Memorandum

TO: All Design Section Staff
FROM: Bijan Khaleghi
DATE: October 2, 2008
SUBJECT: Bridge Mounted Signs

Figure 10.1.2-1

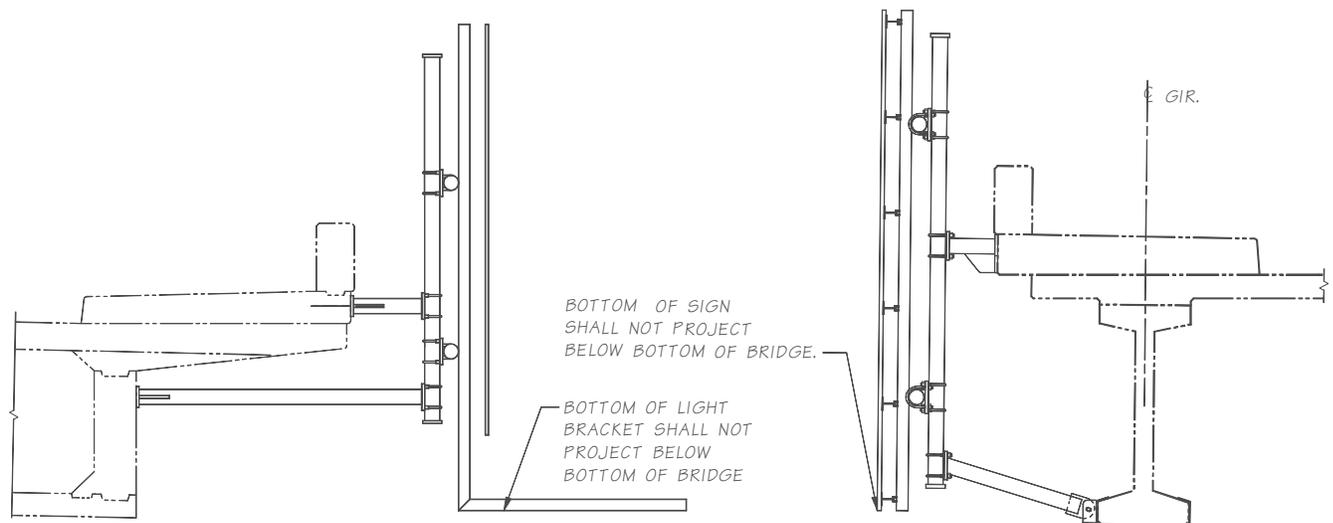
All new signs mounted on bridge structures shall be positioned such that the bottom of the sign or lighting bracket does not extend below the bottom of the bridge as shown in figure 10.1.2-1. The position of the sign does not need to allow for the future placement of lights below the sign. If lights are to be added in the future they will be mounted above the sign. To ensure that the bottom of sign or lighting bracket is above the bottom of the bridge, the designer should maintain at least a nominal 2 inch dimension between the bottom of sign or lighting and the bottom of bridge.
